GJS Plot F, Manchester

Non-material Amendment | 25.09.2024

Z1-SHP-A180-RP-XX-NMA02 | P05

Updated Proposal - F2-SHP-G200-PL-Grd-B5D801 - P06

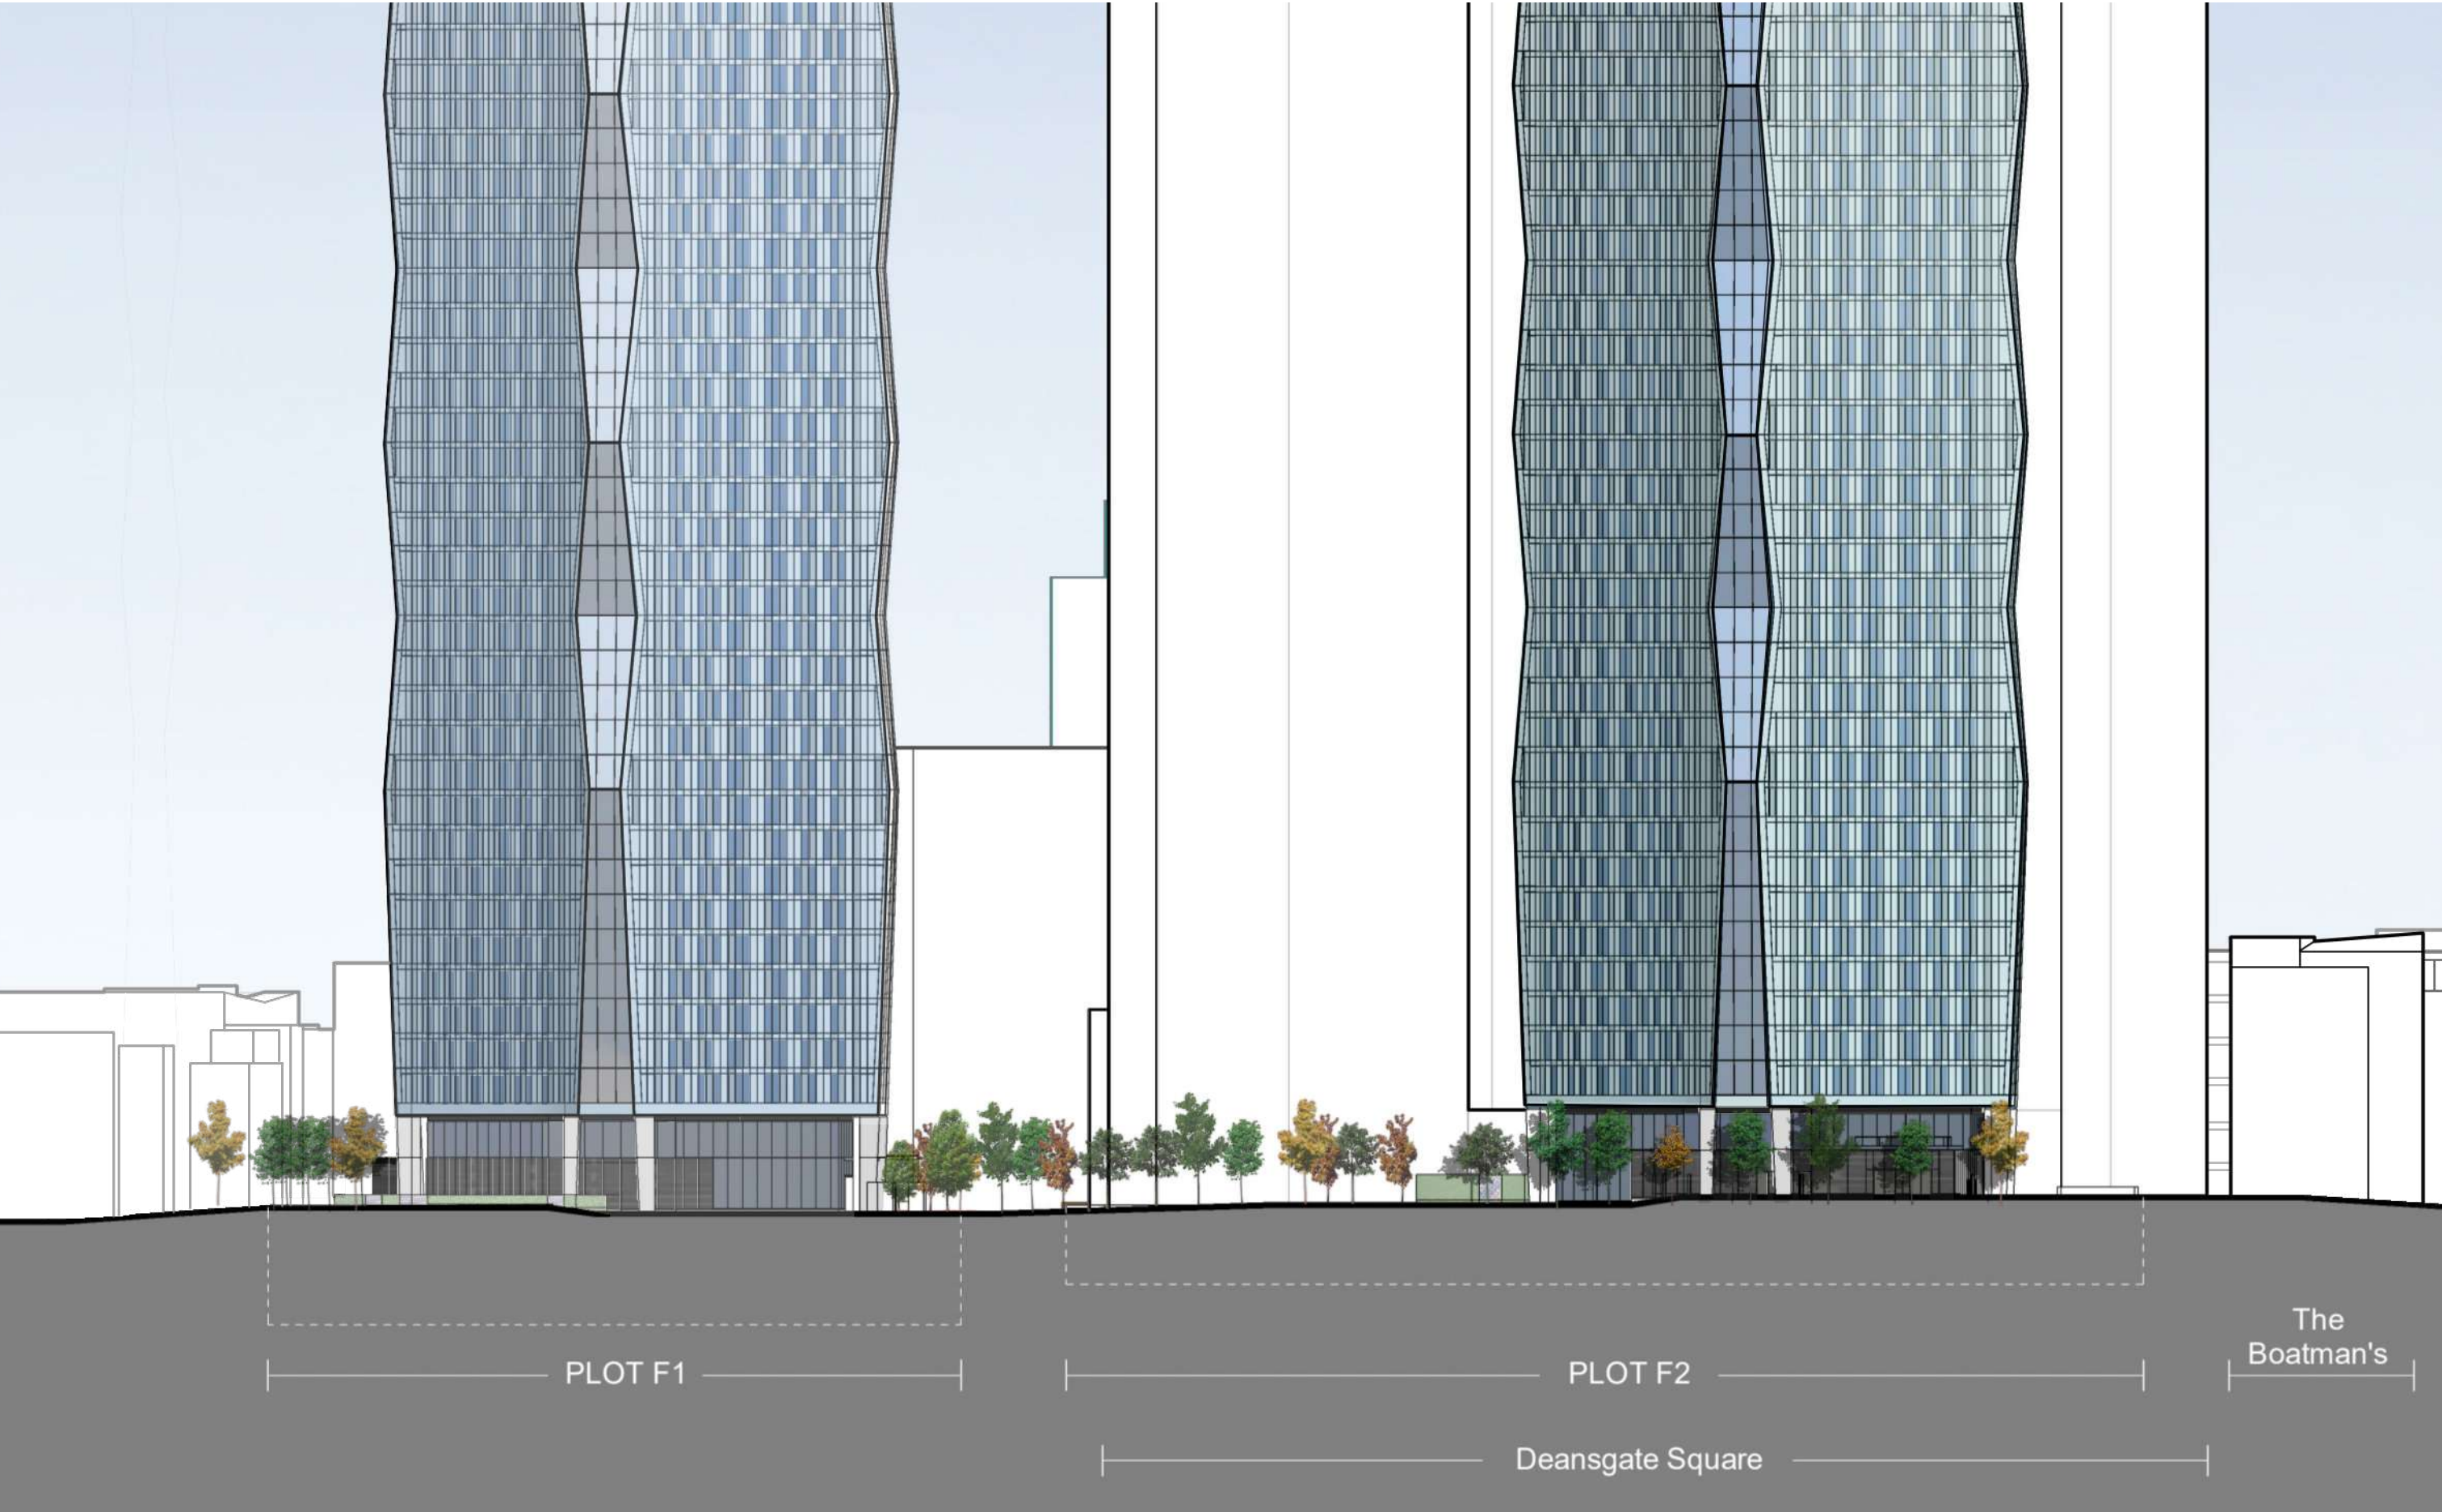
2.	Tower F2 - Pond Street escape stair The standalone escape stair that forms part of the F2 garden wall has been reduced in length but increased in width slightly to accommodate a smoke extract shaft to the stair lobbies. The overall footprint is similar to that of the consented scheme.

Updated Proposal - F1-SHP-G100-EL-XX-B5D801 - P02

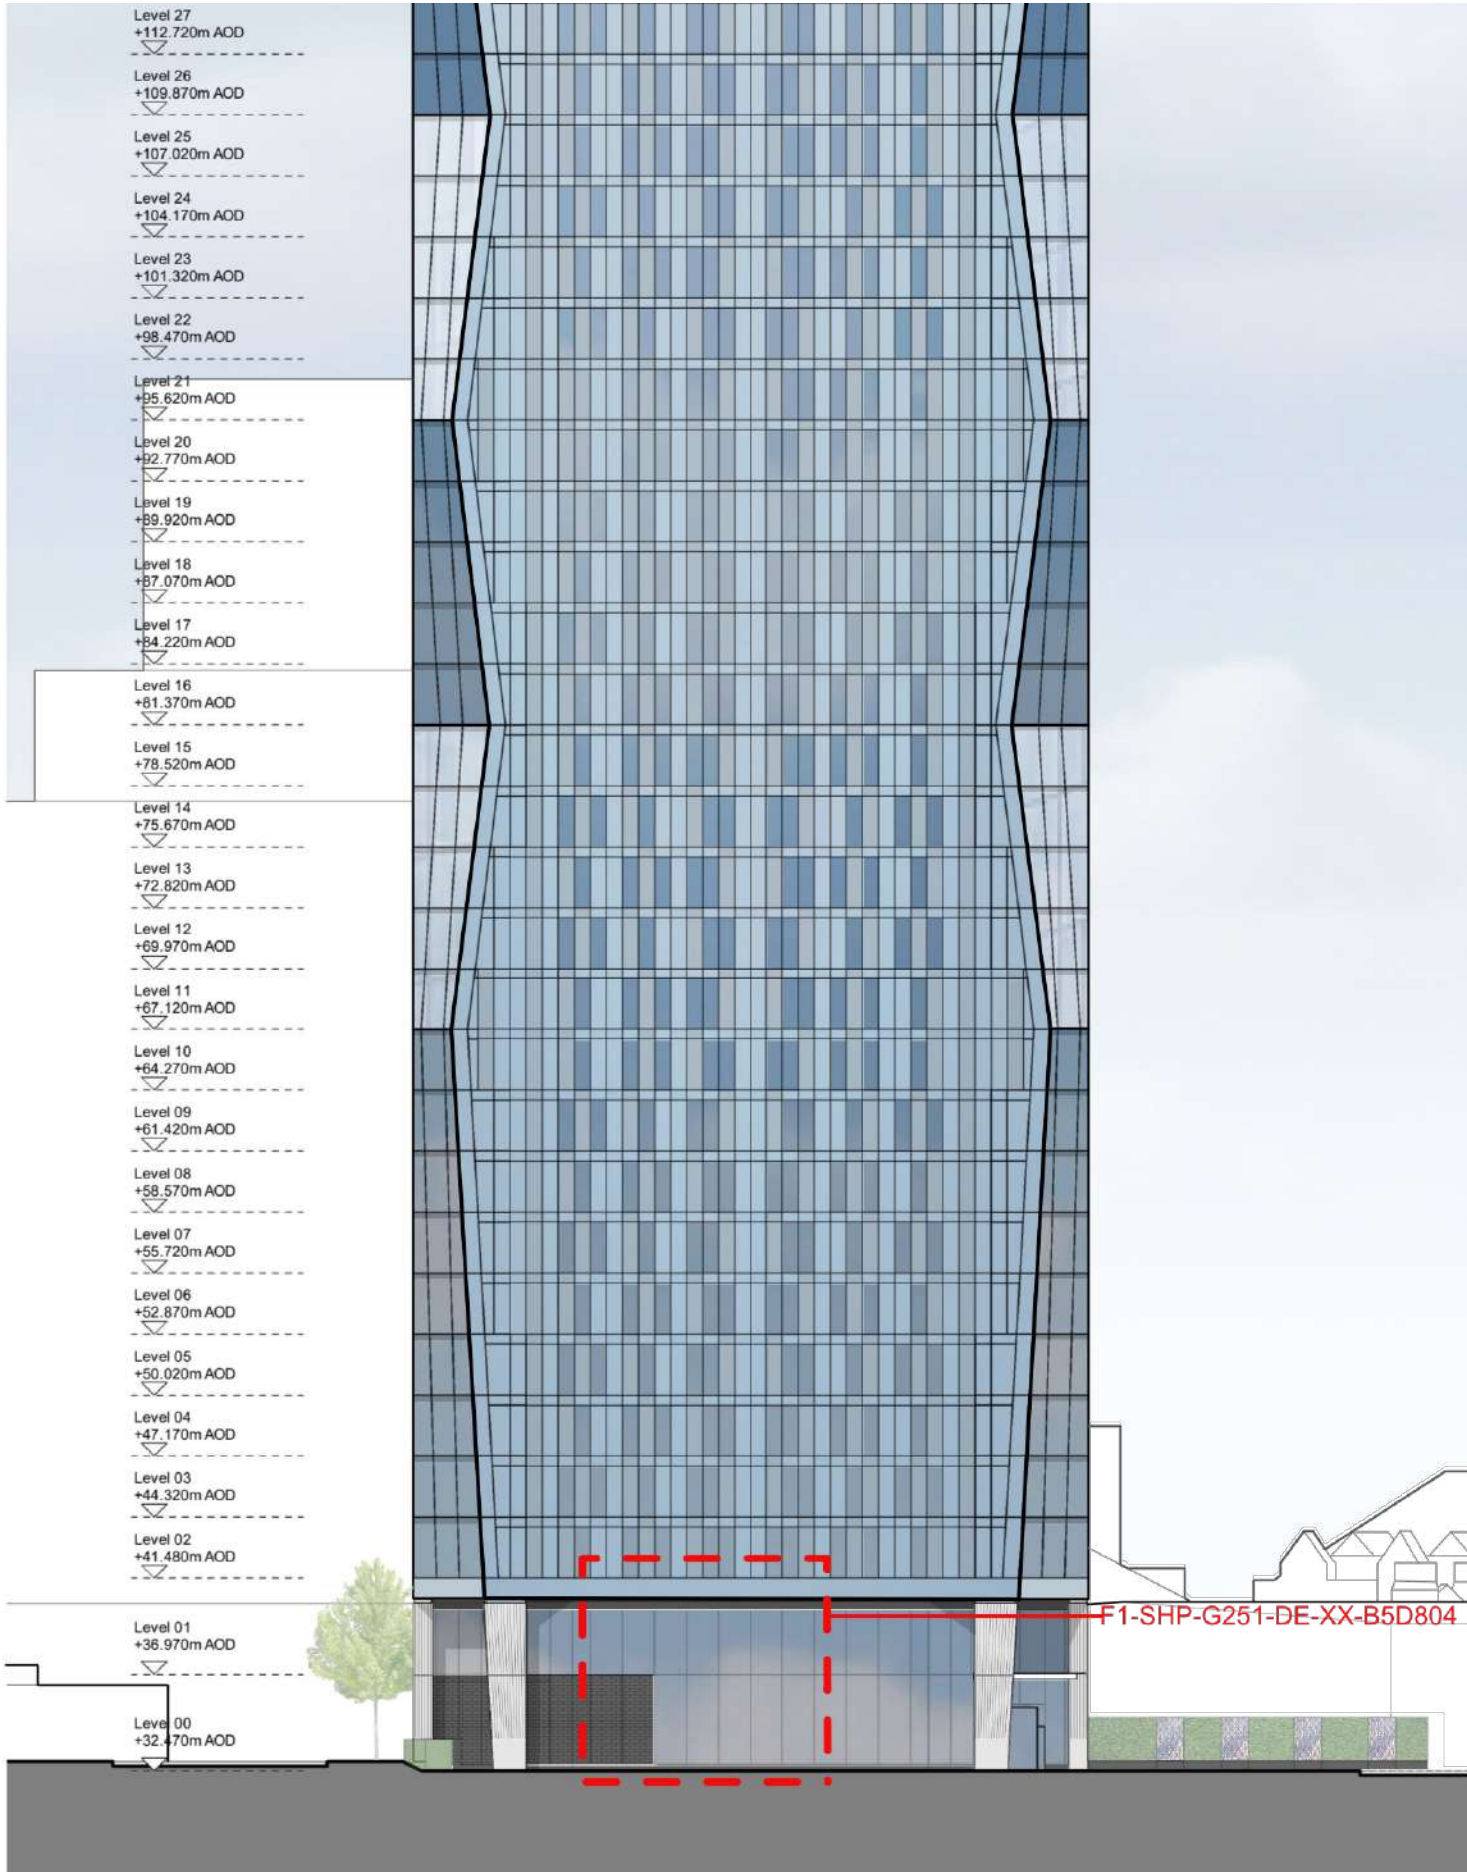
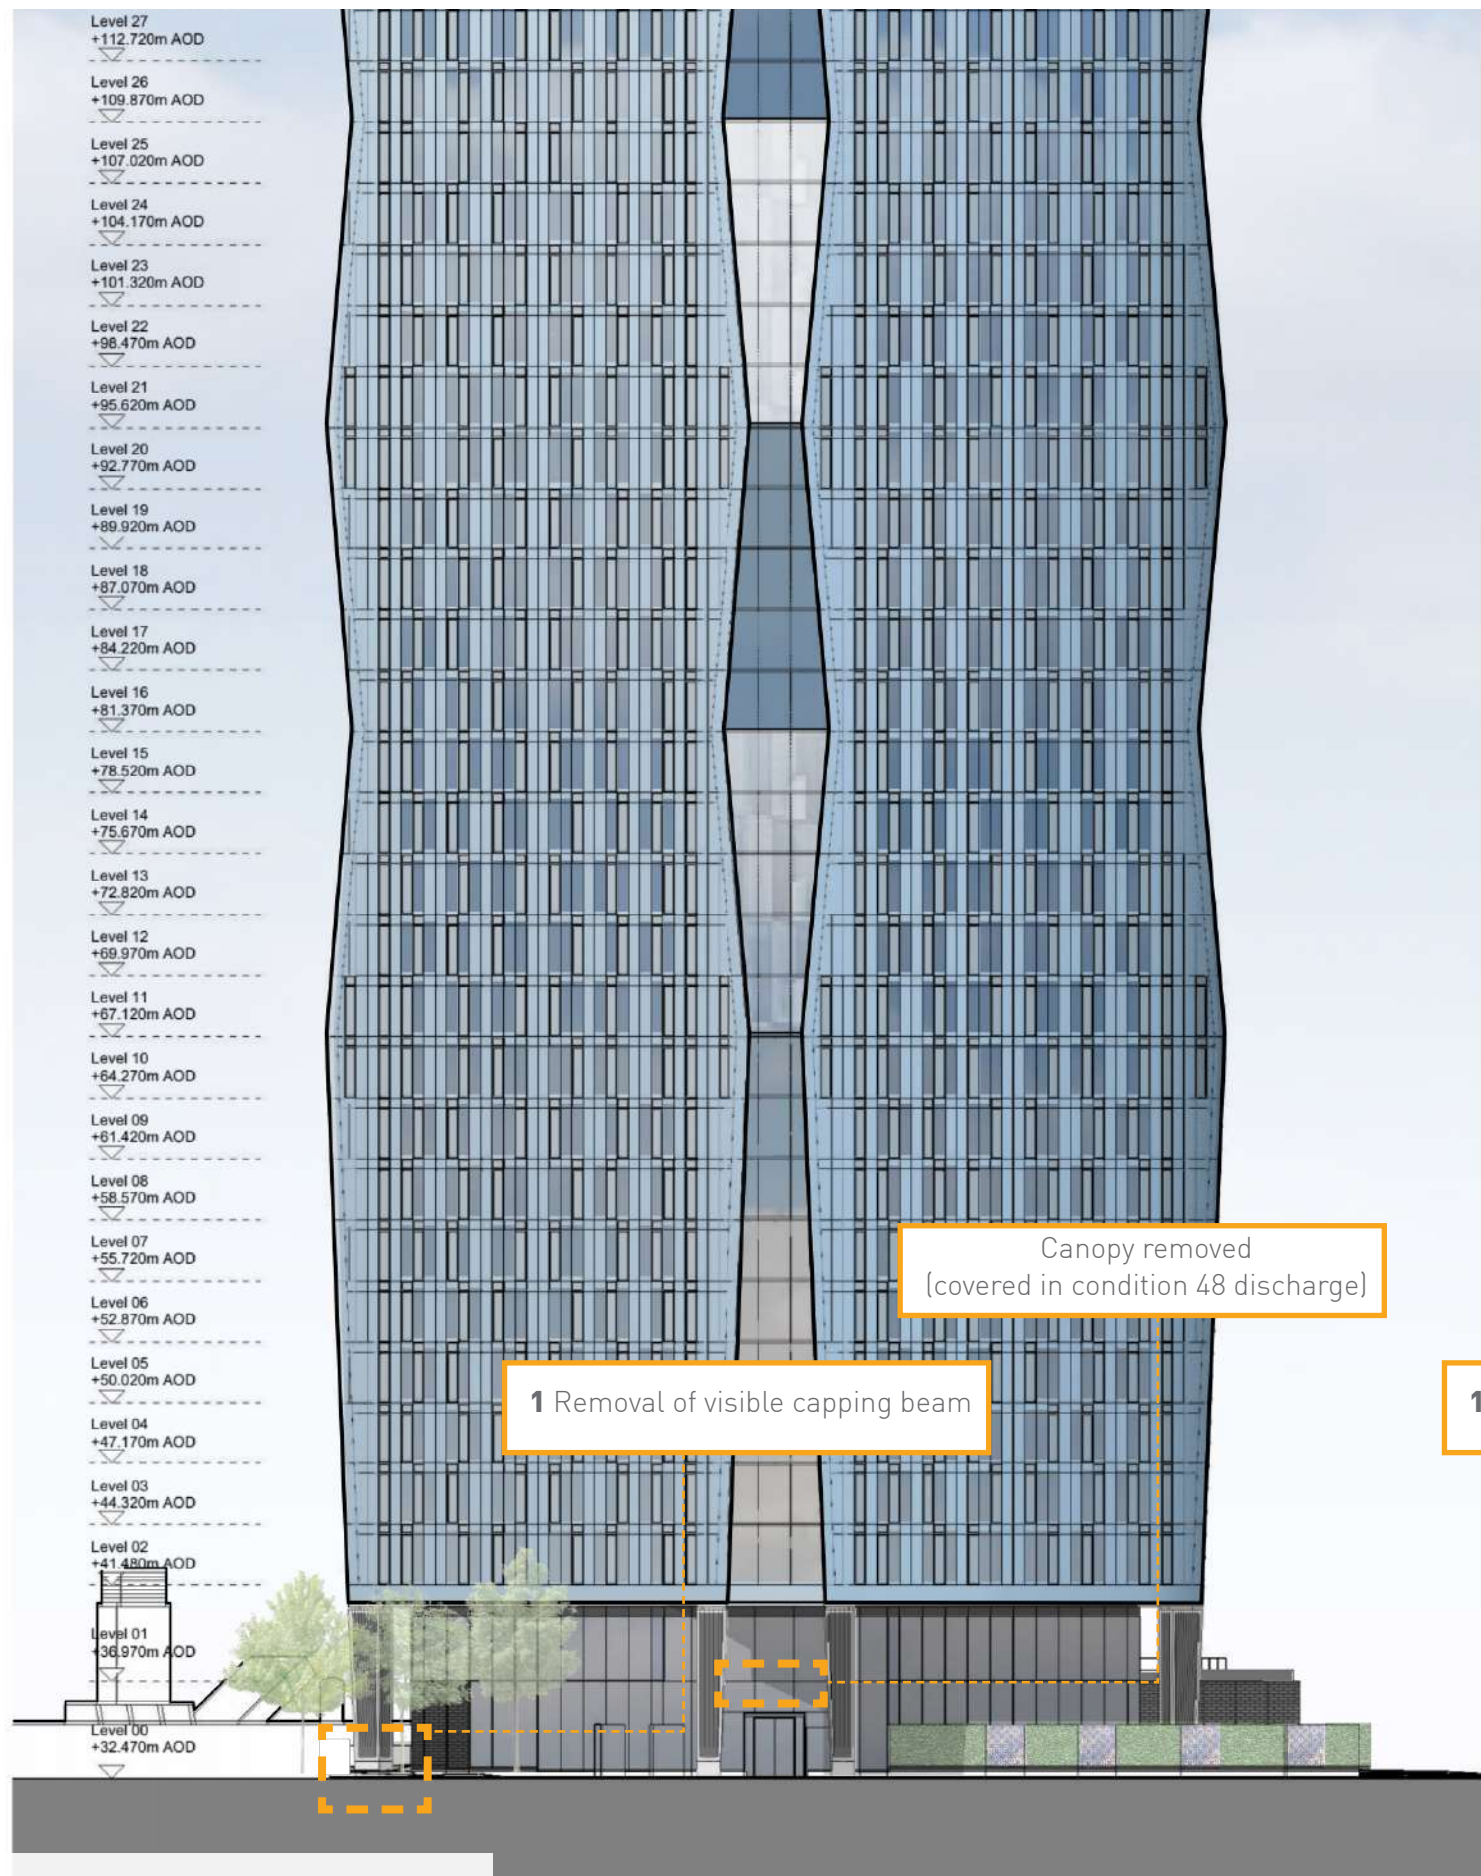
3.	External doors positions amended / design updated a. F1 - Doors to residential amenity In order to provide a more successful interior layout, the two double doors on F1 have been amended to large single leafs and spaced further apart to provide a more usable internal space, whilst maintaining a symmetrical elevation. b. F1 - Doors to refuse store / car park smoke extract Due to the incorporation of the perforated screen in front of the car park extract louvres (as requested by MCC) on F1, it has been neccessary to revise the free area requirement for basement the car park extract system and adjust the door position to the refuse store accordingly. c. F2 - Escape corridor doors The clear width of the escape doors has had to increase to provide the neccessary width for escape. As such this would leave a narrow brick pier at the side of the door. Instead this has been replaced with a larger centralised door allowing the 1500mm panelisation of the facade to be more legible.

Proposed changes - F2-SHP-G251-EL-XX-9001 - P05

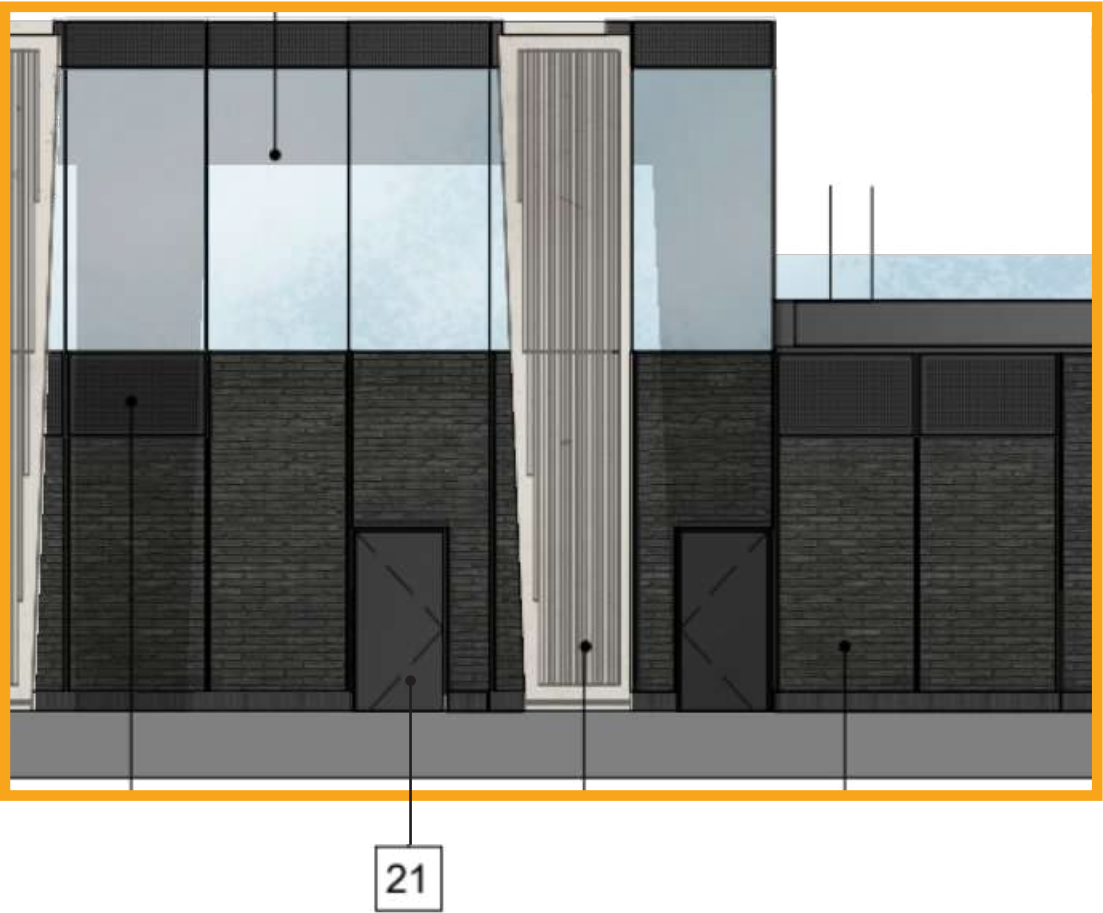
3c. Proposed amendment to doors:

Due to an increase in the required structural opening of the door to facilitate the required clear width for the escape doors. It is no longer feasible to have brick to the side of the door.

Instead a larger centralised door has been introduced, this will help to enforce the panelised language of the podium facade.
